OSA -0599-68

7 February 1968

Subject: LOCAL MODIFICATION TO P/N DN55000 PARACHUTE

NEG. NO. 18413

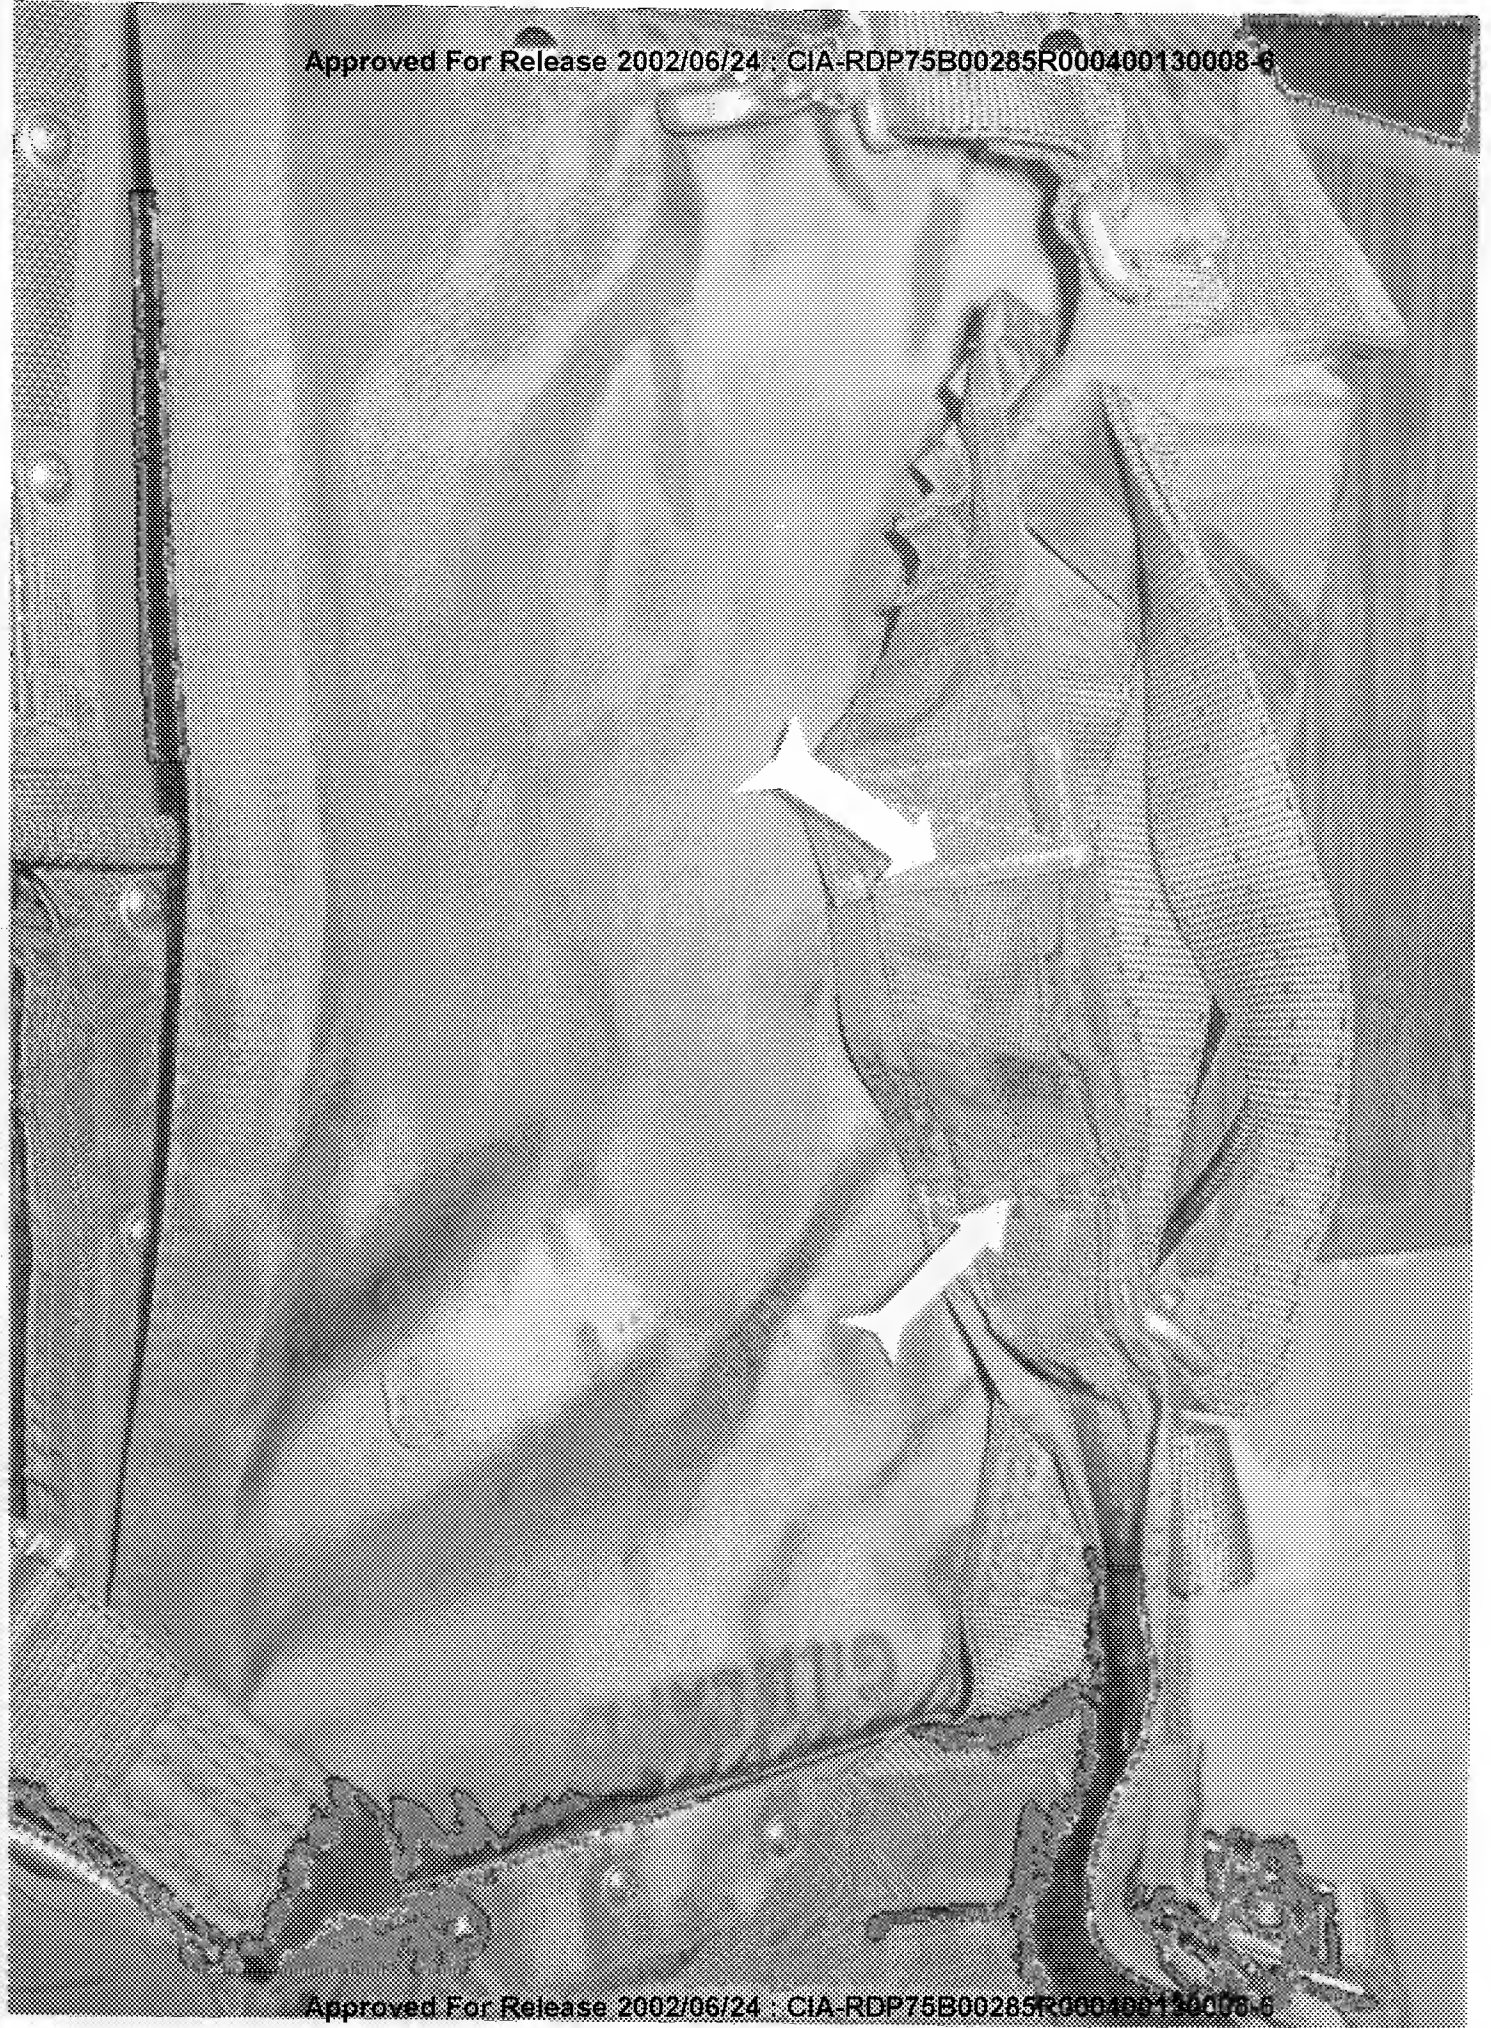
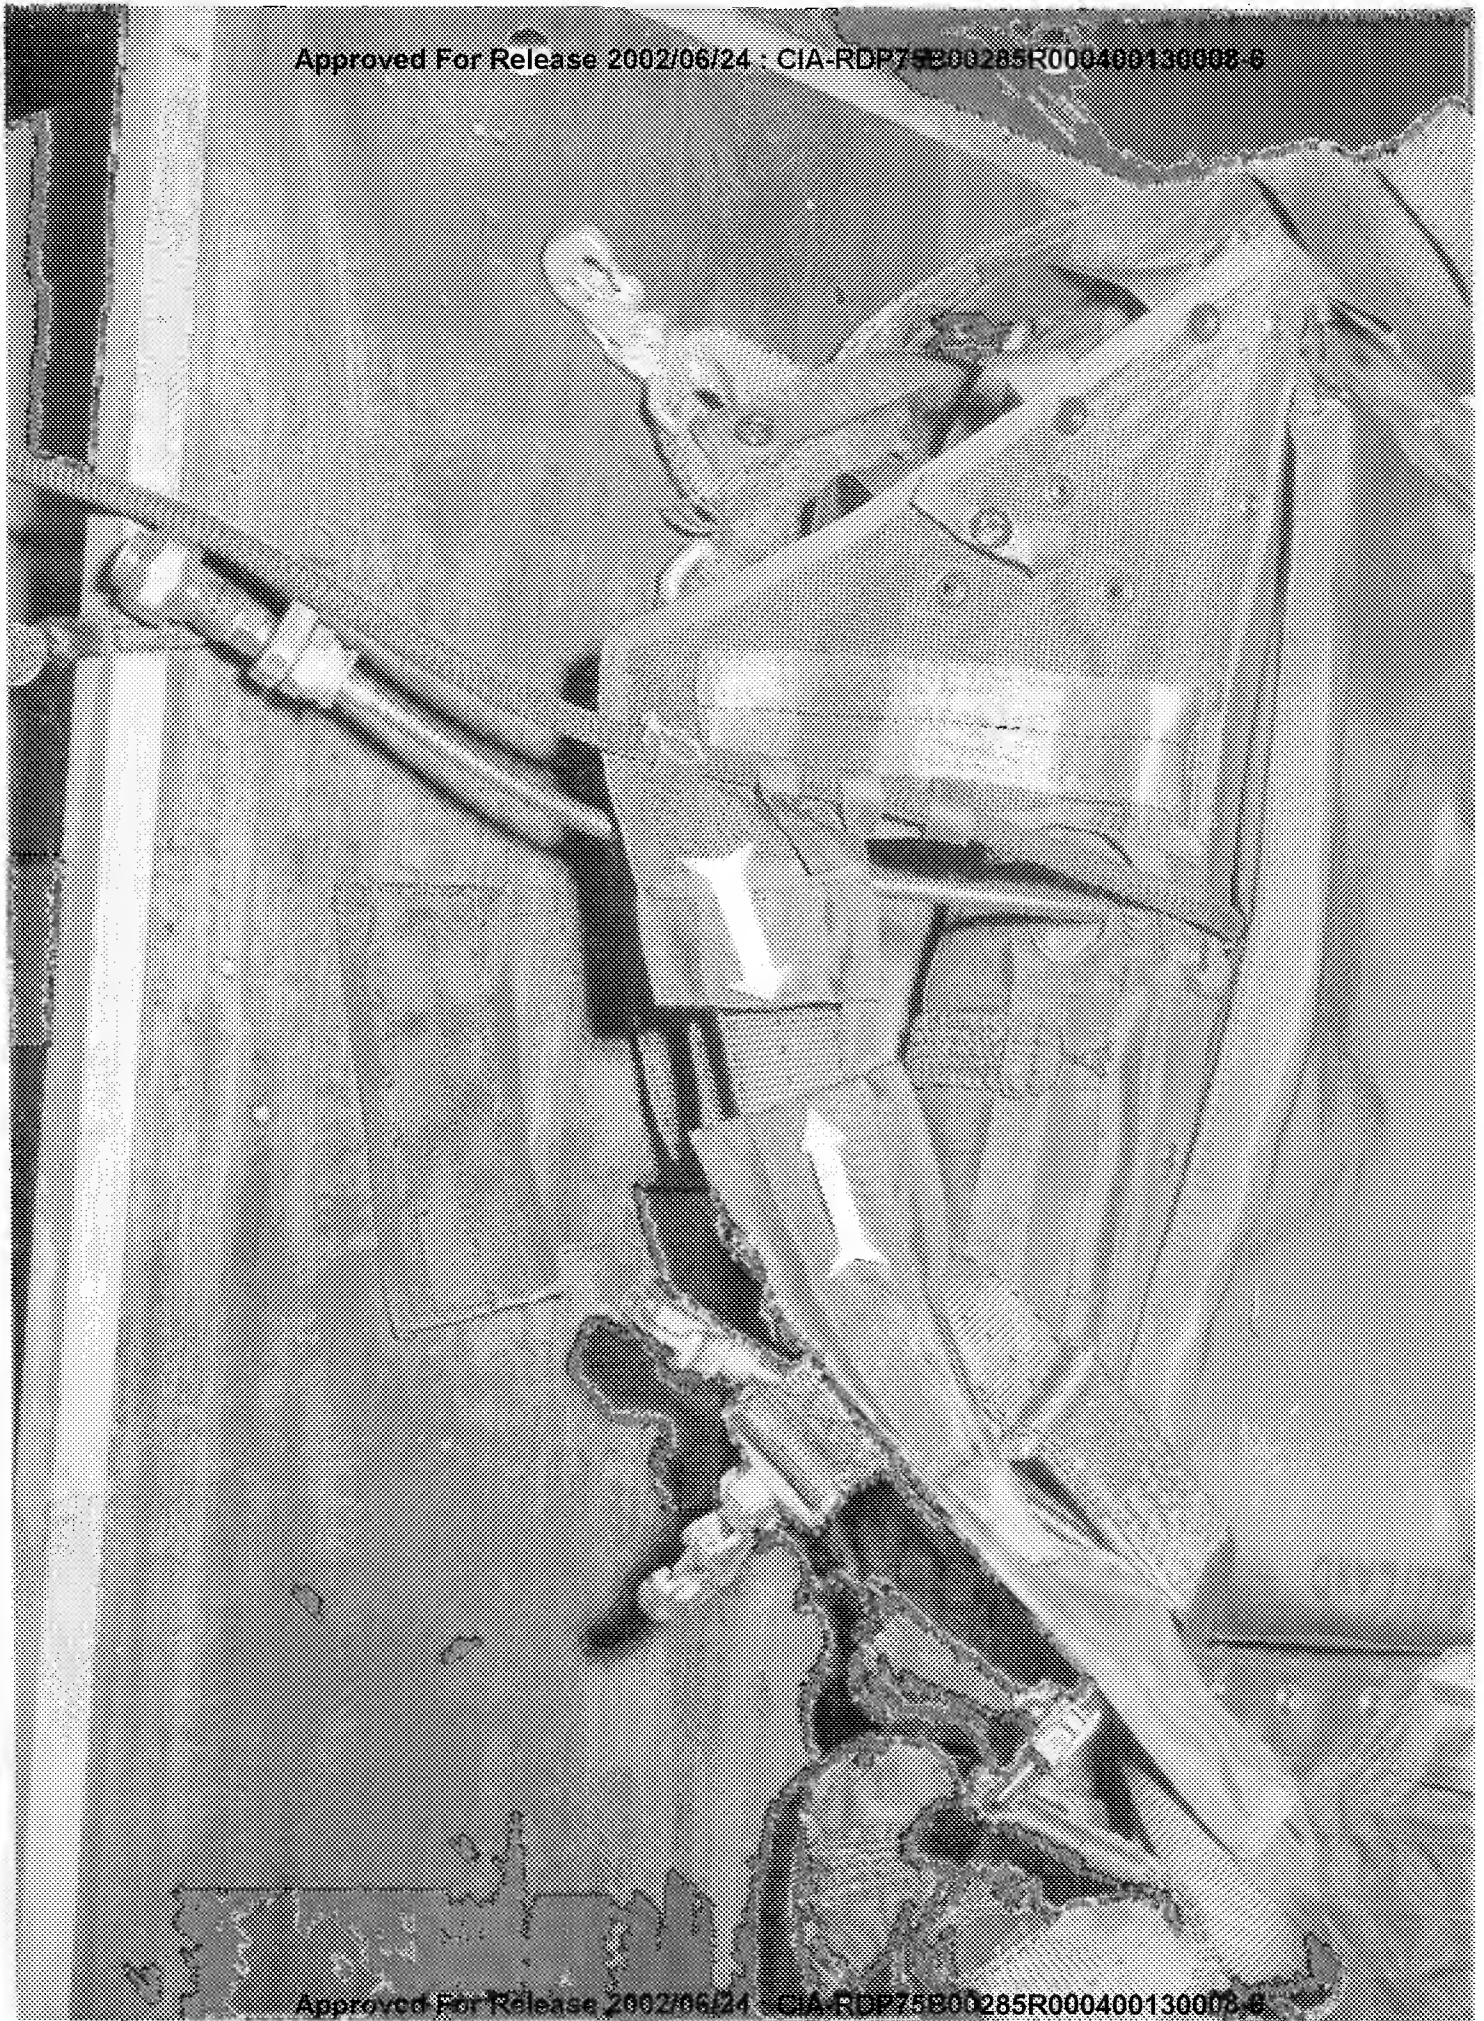
Enclosed photos show a modification incorporated to one DN55000 Parachute, by BW-4 personnel.

The modification consists of a four-inch extension to the non-structural fabric beneath the two vertical lift webs.

This modification was required in order to permit length adjustment of the lift webbing on pilot [REDACTED]

Prior to the modification, the fabric limited the harness length adjustment and put intolerable pressure on Bob's shoulders.
